Environmental
Protection Agency

**Re: Storm Water Inspection at Armstrong World Ind. Inc. / Franklin County
Permit Number: 4GR00085*DG**

Figure 1

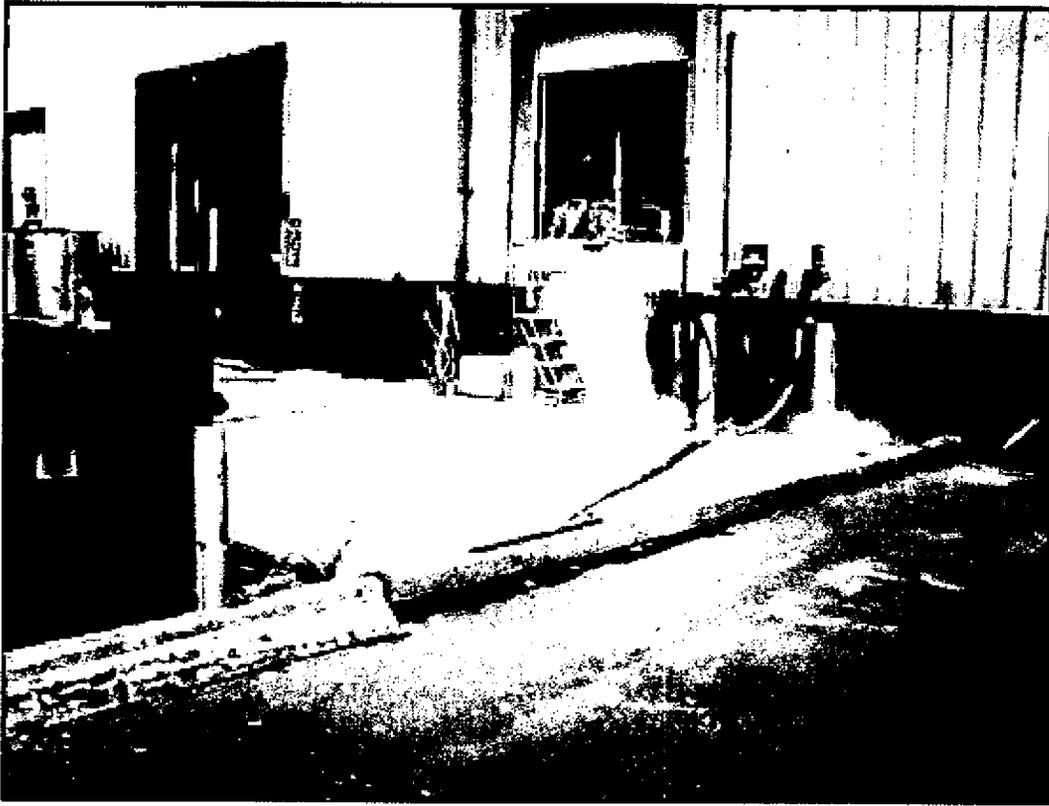
- During the investigation, I noted an apparent waste area located off a loading dock near the entrance to the facility (See Figure 1). It appears that the waste receptacles and the material noted on the pavement are draining to a contained sump. Please identify if this sump is routed to storm water and/or sanitary. In the event this area is routed to your storm water collection system, additional BMPs are expected to eliminate this potential threat.
